Title: Riverdale Sewer Lift Station – West Force Main- Change Order #1
Dellinger Inc.

Change Order

Project: Riverdale Sewer Lift Station - West Force Main Contract:	Owner: City of High Point	Owner's Contract No.: 06-211821
Contractor: Dellinger, Inc.		Date of Contract: 5/3/2021
		Engineer's Project No.: 2784-M

**CONTRACT CHANGE ORDER NO. 1 MEMORANDUM
RIVERDALE SEWER LIFT STATION – WEST FORCE MAIN
CITY OF HIGH POINT, NORTH CAROLINA
TWC 2784-M AND 06-211821**

Aerial Site Image of Pavement Calculations

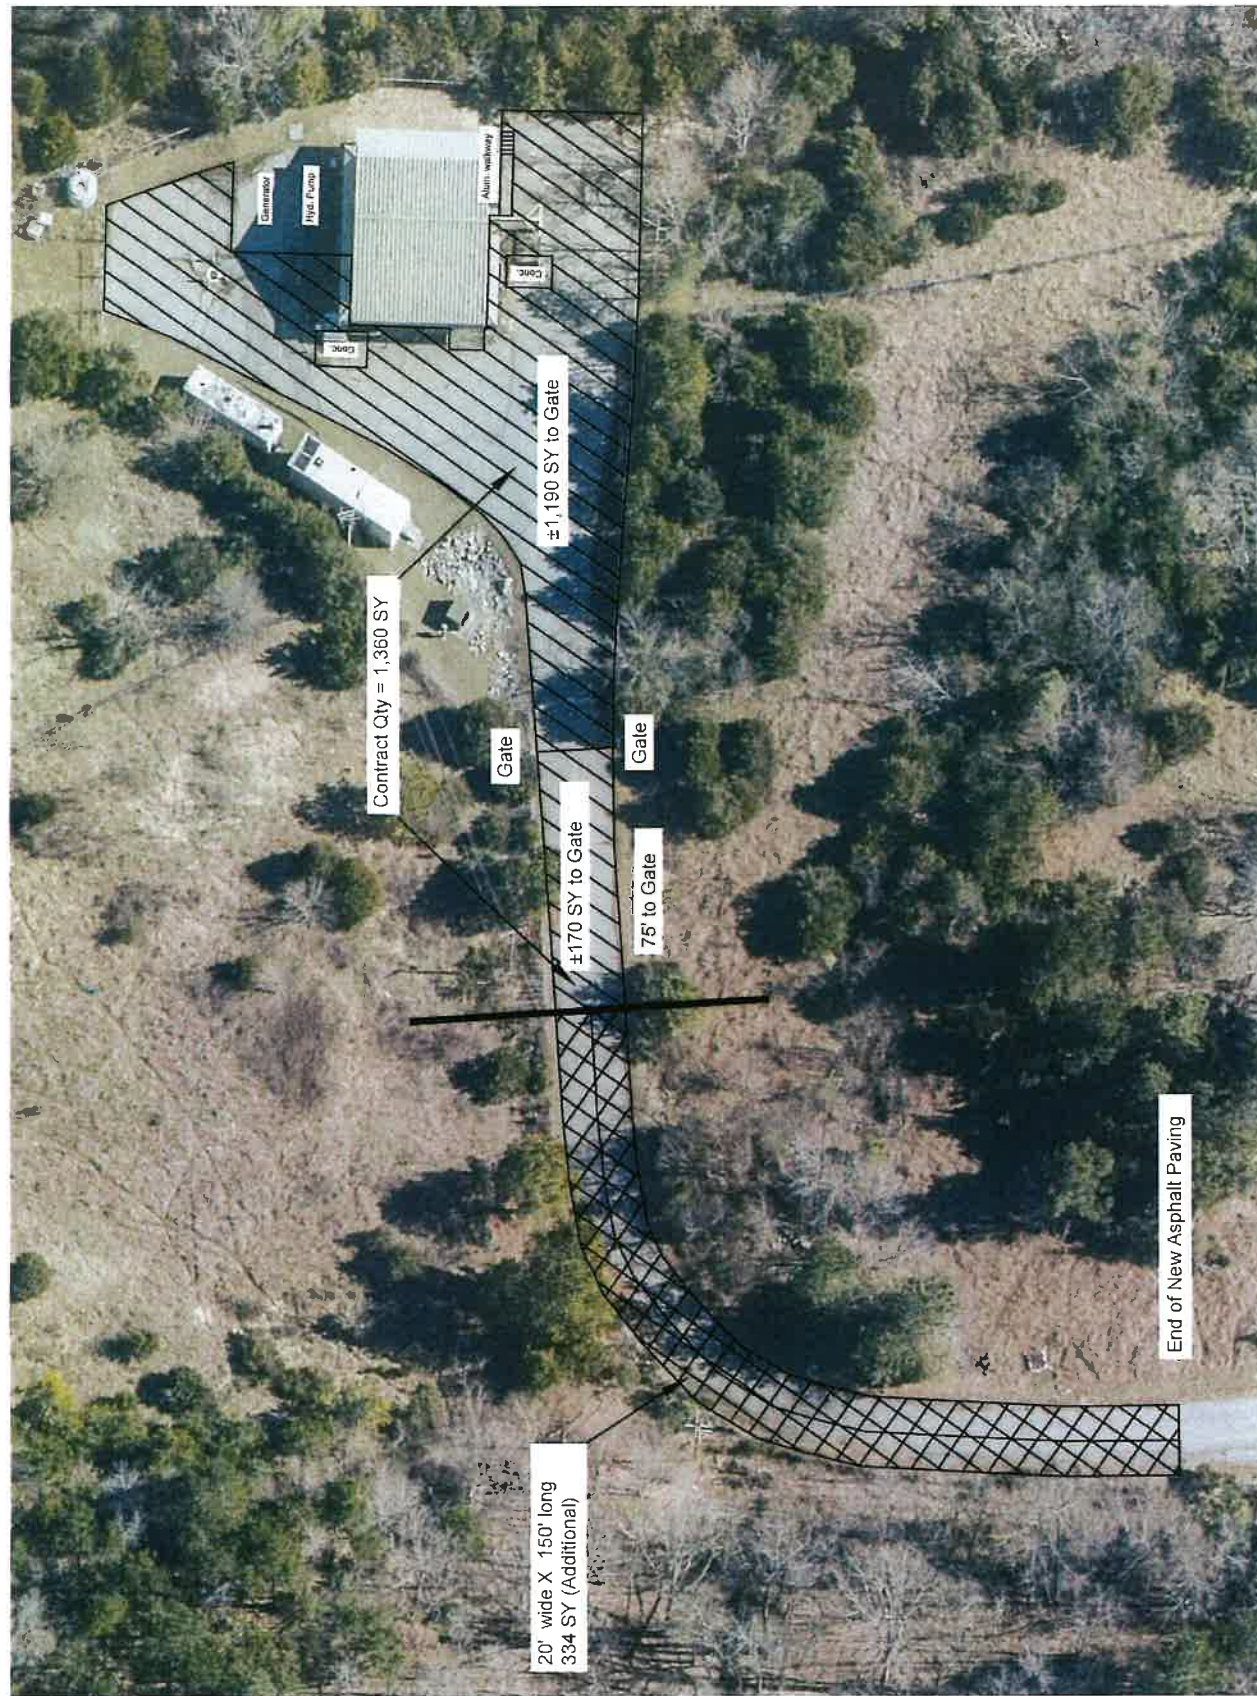
Extend Paving Limits

The road leading to the pumpstation outside of the gate to approximately the top of hill has deteriorated to the point it is needing to be resurfaced. The current contract includes the resurfacing of existing parking lot at the pump station. It is recommended that The City have contractor extend the paving outside of the parking to the top of the hill to maintain a viable access to pump station. This will include an additional 420 SY of asphalt paving at the existing bid price of \$20.00/SY. The additional cost is \$8,400.00
